Date: 07/23/2026
CAL FTL 54-043_REV2

Subject: 5th Generation Cascadia Headlamp Turn Signal Not Functioning

Make: Freightliner

Model: 5th Generation Cascadia

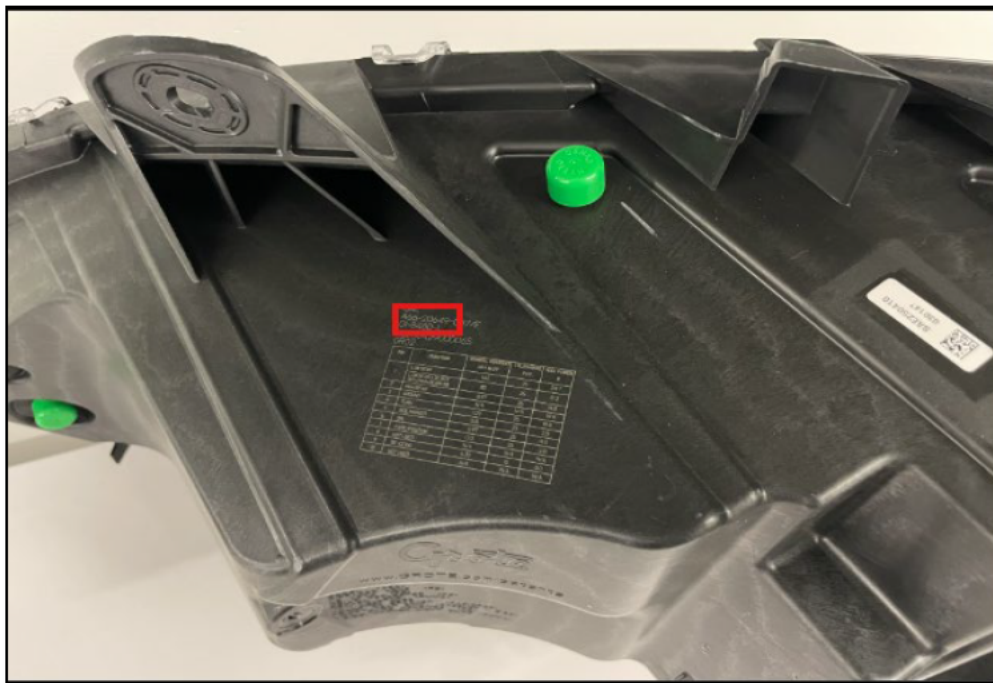
To identify known good headlamps, follow the instructions below.

1. Park the vehicle on a level surface, shut down the engine, and set the parking brake. Chock the tires.
2. Identify the headlamp part number (A66-20649-XXX) by locating the part number stamp on the top of the headlamp housing.

3. If the part number is A66-20649-006 through A66-20649-009, it is a suspect part and should be replaced.
4. If the part number is A66-20649-010/011, follow instructions below to determine if the part is a suspect part.

- a. Located under the DTNA part number is the supplier part number (01-8480-X). To the immediate right of the supplier part number is a deviation number. If the deviation part number is PDNY01+D4, the part is good and does not need replacement. If the deviation number is PDNY01+C9, replace the headlamp.
